Accessibility Compliance Report For DA Application

Project Address: 96 - 98 Lethbridge St & 42 - 46 Evans St, Penrith NSW
Prepared For: Free Burnville Pty Ltd

Issue No: B
Issue Date: 02/12/2020
Report No: 20-109

Ground Level

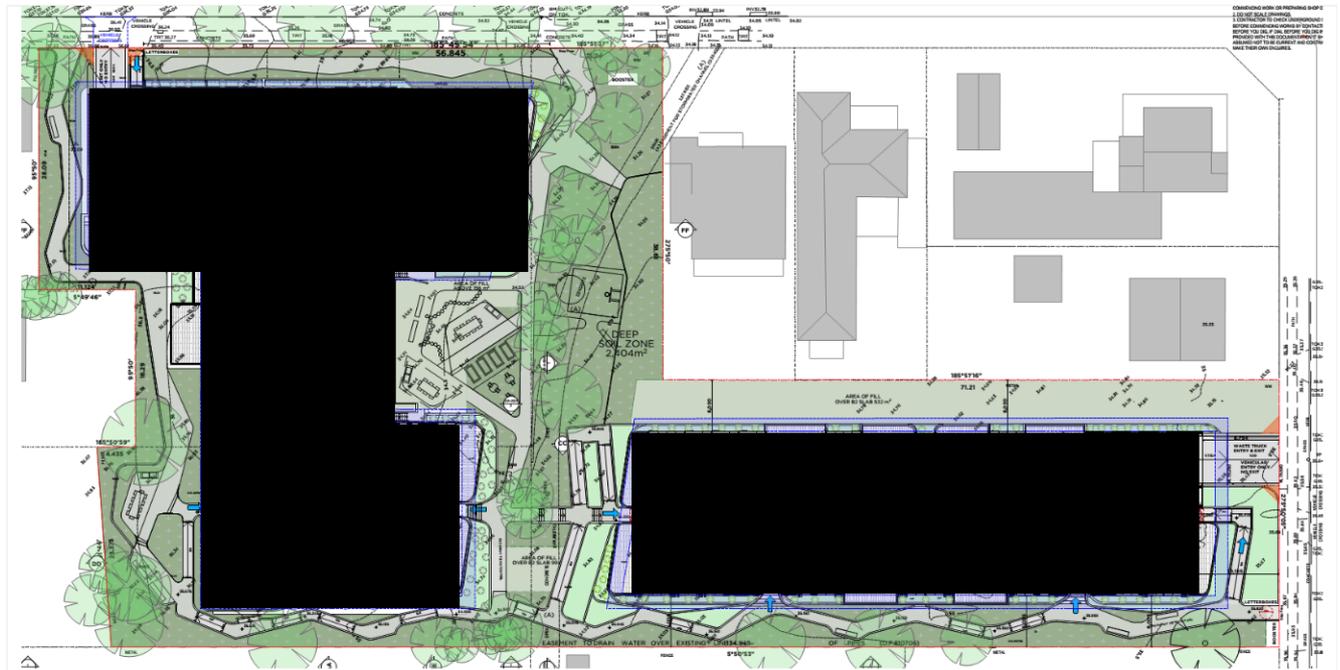
(a) Access way must be provided to a building;			
I. From the main points of a pedestrian entry at the allotment boundary	<input type="checkbox"/>	<input type="checkbox"/>	✓
II. From another accessible building connected by a pedestrian link	<input type="checkbox"/>	<input type="checkbox"/>	✓
III. From any required accessible car parking space on the allotment	<input type="checkbox"/>	<input type="checkbox"/>	✓
Reference: Figure 6, Figure 7, Figure 9, Figure 11, Figure 12, Figure 13, Figure 14 Notes: See Att.01 – Building A & Building B are connected together with a continues path of travel. In addition, a continues step free access way from the main points of a pedestrian entry at the allotment boundary to both building “A” & “B” are provided.

(b) In a building required to be accessible,			
I. an accessway must be provided through the principal pedestrian entrance,	<input type="checkbox"/>	<input type="checkbox"/>	✓
II. through not less than 50% of all pedestrian entrances including the principal pedestrian entrance; and	<input type="checkbox"/>	<input type="checkbox"/>	✓
III. in a building with a total floor area more than 500 m2, a pedestrian entrance which is not accessible must not be located more than 50 m from an accessible pedestrian entrance.	<input type="checkbox"/>	<input type="checkbox"/>	✓
Notes: See Att.01 – The main pedestrian entrances at Lethbridge & Evan Street are both accessible.

(c) Where a pedestrian entrance required to be accessible has multiple doorways—			
I. if the pedestrian entrance consists of not more than 3 doorways — not less than 1 of those doorways must be accessible;	<input type="checkbox"/>	<input type="checkbox"/>	✓
II. if a pedestrian entrance consists of more than 3 doorways — not less than 50% of those doorways must be accessible	<input type="checkbox"/>	✓	<input type="checkbox"/>
Notes: See Att.01 – Can be compliant at CC stage

(d) Access way must have a clear opening of 850mm in accordance with 1428.1	<input type="checkbox"/>	<input type="checkbox"/>	✓
Reference: Notes: See Att.01 – Can be compliant at CC stage			
D3.3 Access To Buildings	ADR	N/A	C

(a) every ramp and stairway must comply with;			
I. For a ramp, clause 10 of AS 1428.1	<input type="checkbox"/>	<input type="checkbox"/>	✓
II. For a stairway, clause 11 of AS 1428.1	<input type="checkbox"/>	<input type="checkbox"/>	✓
III. For a fire isolated stair, clause 11.1(f) and (g) of AS 1428.1	<input type="checkbox"/>	<input type="checkbox"/>	✓
Reference: Figure 4, Figure 5, Figure 6, Figure 7, Figure 8, Figure 9, Figure 10, Figure 11, Figure 12, Figure 13, Figure 14, Figure 15 Notes: See Att.01 – Can be compliant at CC stage

Att.01 URBAN Link Plans Issue A dated 27.11.2020

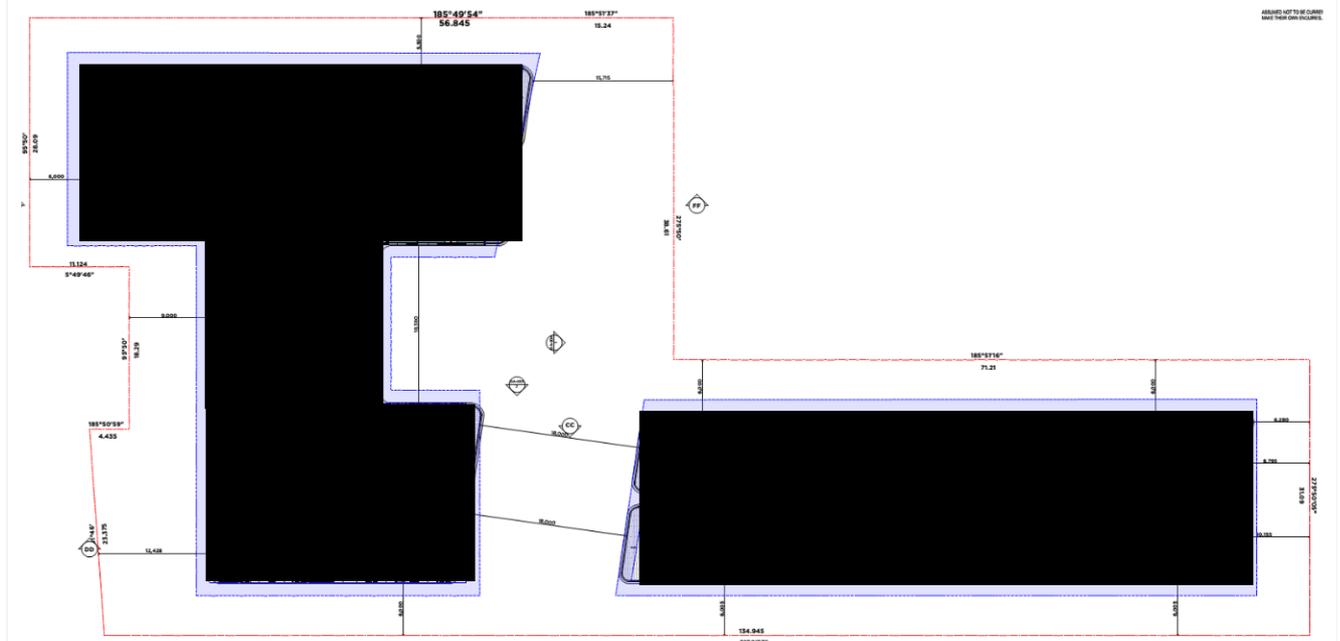
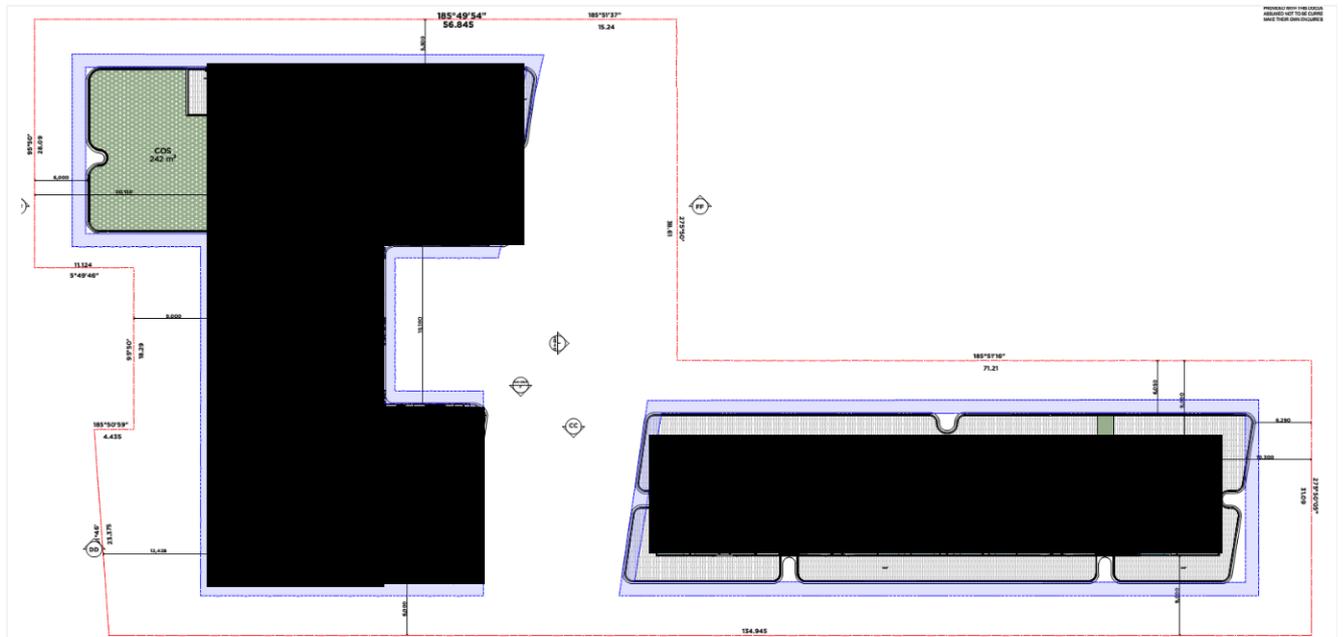
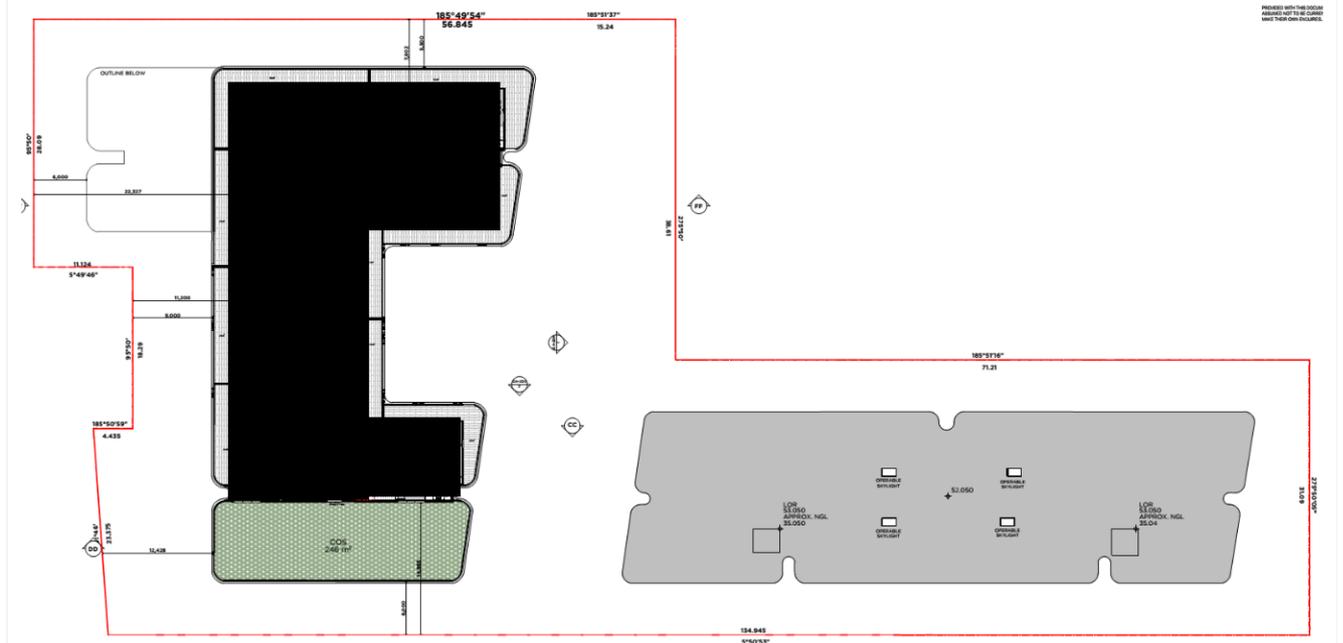
V. Under an overhead obstruction less than 2 m above floor level, other than a doorway if no barrier is present.	<input type="checkbox"/>	✓	<input type="checkbox"/>
VI. Or when an access way meets a vehicular way adjacent to any pedestrian entrance to a building, if there is no kerb or kerb ramp present.	<input type="checkbox"/>	✓	<input type="checkbox"/>
Reference: Figure 04, Figure 12, Figure 15 Notes: See Att.01 – TGSI's to be made compliant at CC stage

(b) Tactile ground surface indicators must comply with sections 1 and 2 of AS/NZS 1428.4.1. Reference: Figure 15 Notes: See Att.01 – Can be complaint at CC stage	<input type="checkbox"/>	<input type="checkbox"/>	✓
